NOTICE OF DECISION

**URBAN GROWTH AREA PRELIMINARY DECLARATION / CLASS 3 SITE PLAN REVIEW / CLASS 2 ADJUSTMENT / CLASS 2 DRIVEWAY APPROACH PERMIT
CASE NO. UGA-SPR-ADJ-DAP17-01**

APPLICATION NO. : 17-102293-LD, 17-102294-RP & 17-102296-ZO

NOTICE OF DECISION DATE: May 17, 2017

**PRELIMINARY
 SITE PLAN**

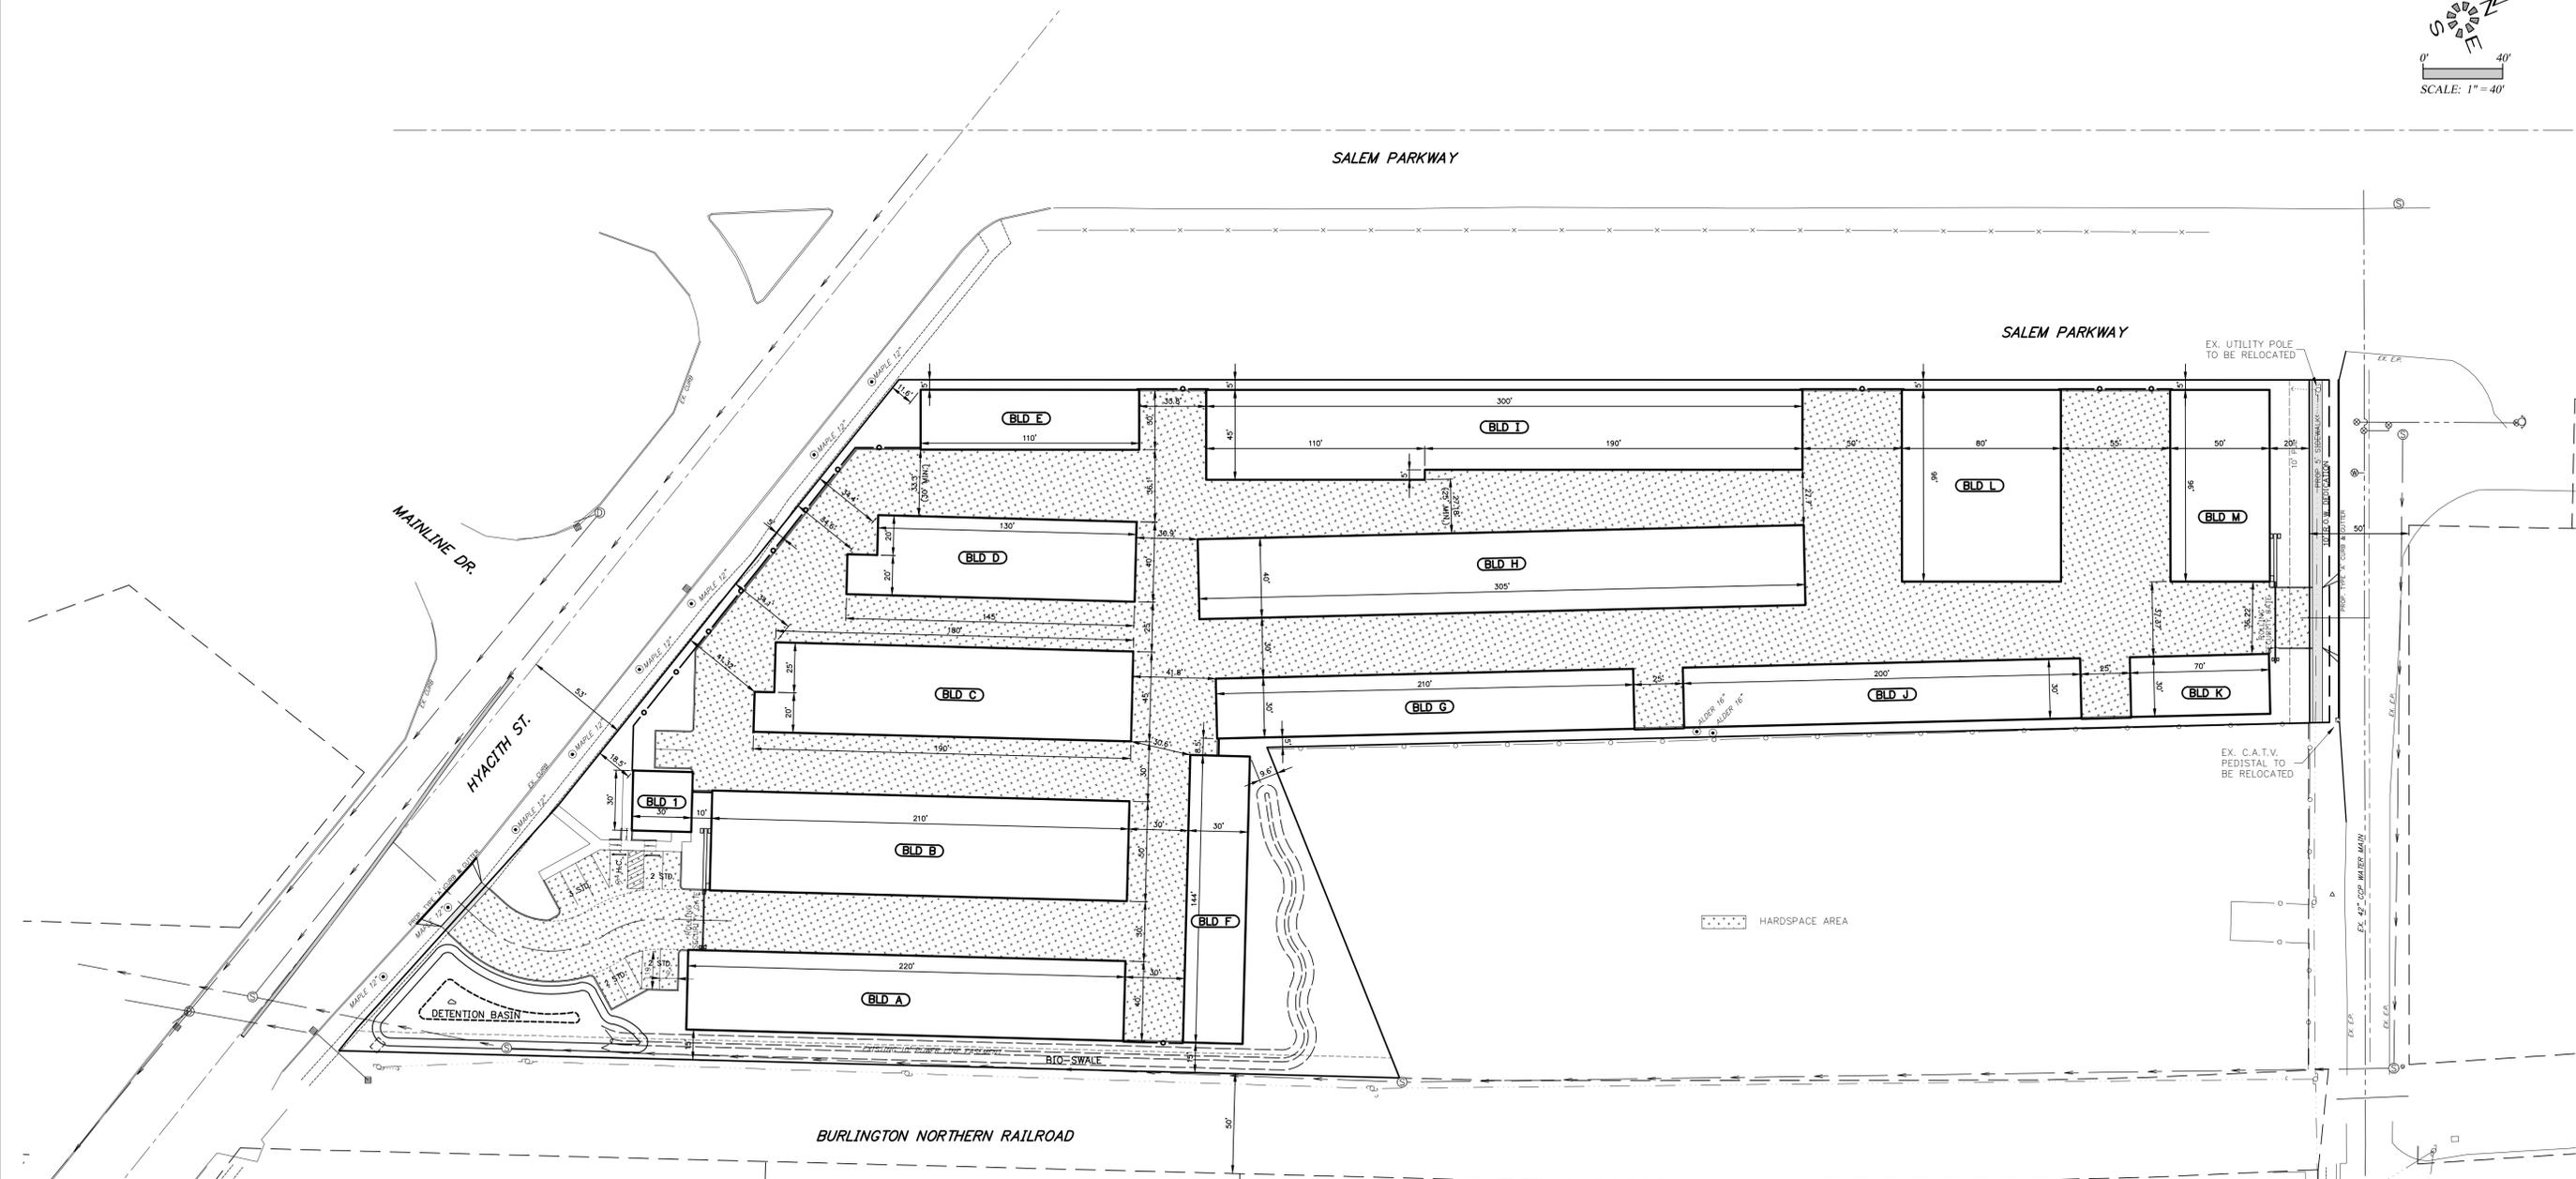
Finding: The proposed site plan indicates that the setback along right-of-way of Claxter Road and the interior property lines meet the building and vehicle setback requirements. The proposed site plan indicates setback along right-of-way Hyacinth Street NE and Salem Parkway meet the building setback requirements. The applicant is requesting an adjustment to required landscaped area adjacent to the street property lines long Hyacinth Street NE and Salem Parkway NE from 10 feet to 5 feet and is analyzed in Section 4, page 13, of this report.

Finding: The applicant is proposing a fence along the property lines. The proposed plans do not indicate height or material of the fence. Although, the written statement does indicate material and height of the fence to be 6-foot sight-obscuring with location not specifically specified. To ensure compliance with standards, the following condition is necessary:

The proposed site plan indicates that a total of 12 standard off-street parking spaces will be provided, which is consistent with the minimum and maximum off-street parking requirements of SRC Chapter 806.

Finding: No bicycle parking is indicated on the proposed plans.

Finding: The proposed site plan does not indicate an off-street loading area. Although existing pavement will provide adequate area to accommodate loading areas.

The proposed driveway to Hyacinth Street NE does not meet the spacing standards described in SRC 804.035(d). The applicant submitted findings indicating the driveway to Hyacinth Street NE is essential to provide efficient circulation through the site. City staff concur with these findings and have determined there are no opportunities for providing an alternate location or to construct a shared driveway with the limitations of the railroad crossing on the east and Salem Parkway NE, west of the subject property. A raised median on Hyacinth Street NE will be required to restrict turning movements to right-in and right-out only, limiting potential conflicts. Therefore, the proposed driveway equally or better meets the intent of the standard by providing safe access and minimizing traffic conflicts.

Condition 7. The vehicle use areas adjacent to Claxter Road NE and Salem Parkway NE that is less than 10 feet in width shall be landscaped with a minimum of 1 plant unit per 10 square feet of landscaped area.

Condition 8: The adjusted standards, as approved in this zoning adjustment, shall only apply to the specific development proposal shown in the attached site plan. Any future development, beyond what is shown in the attached site plan, shall conform to the requirements for the development site, unless adjusted through a future land use action.

Figure 1. Key Safety Considerations Surrounding Project Site

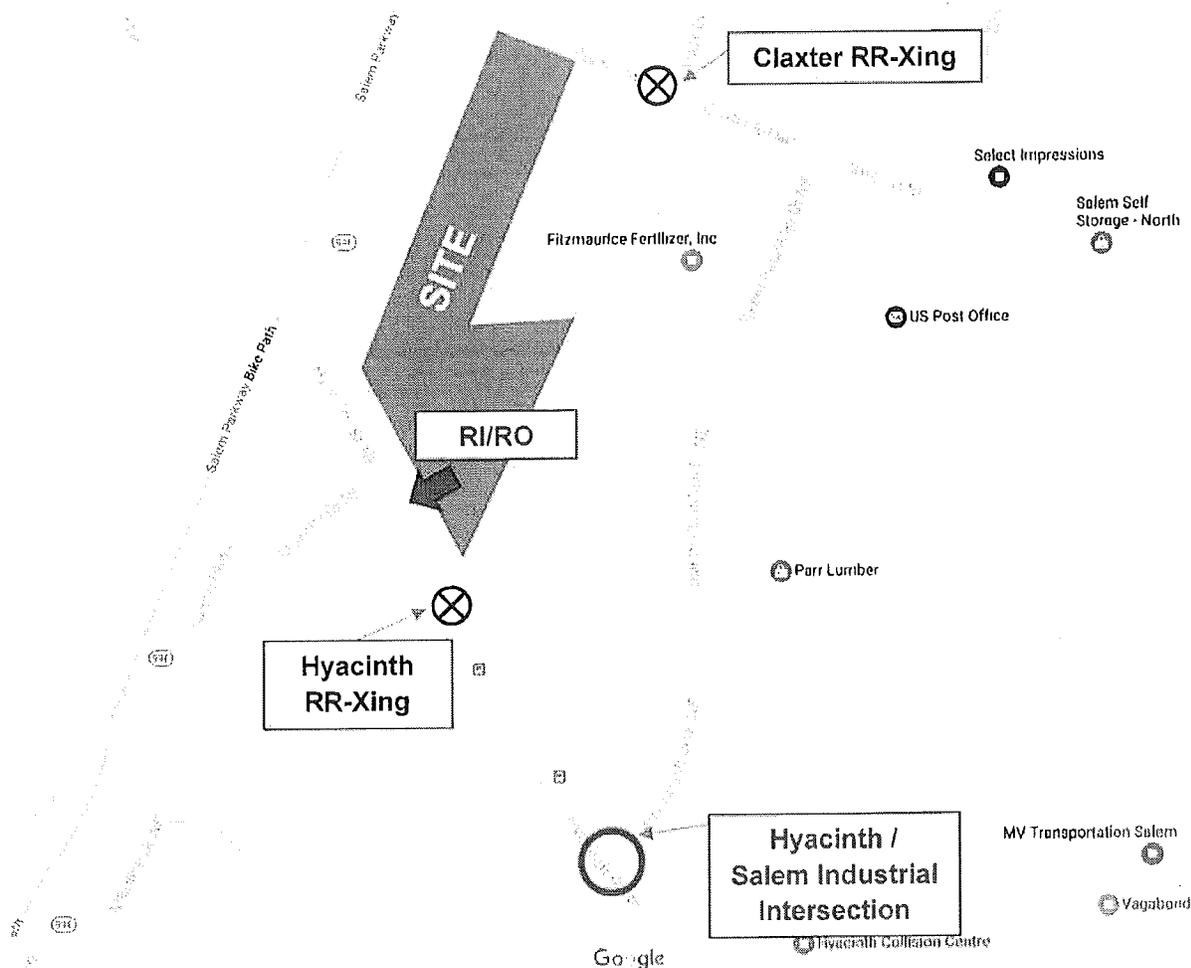
A high-level safety evaluation was completed for each of the four locations shown on Figure 1, including the risk for conflicts, the potential severity of a conflict that does occur, and the level of exposure to each type of conflict (daily site generated trips). The conflict characteristics of each location are summarized below, and compared with exposure estimates in Table 1 on the following page.

Providing a right-in/right-out access onto Hyacinth Street would add low risk, low severity conflict points to Hyacinth Street. However, as shown in Table 1, providing access via Claxter Road only would force a large portion of the site generated traffic to travel through existing locations that have a higher conflict risk and higher conflict severity.
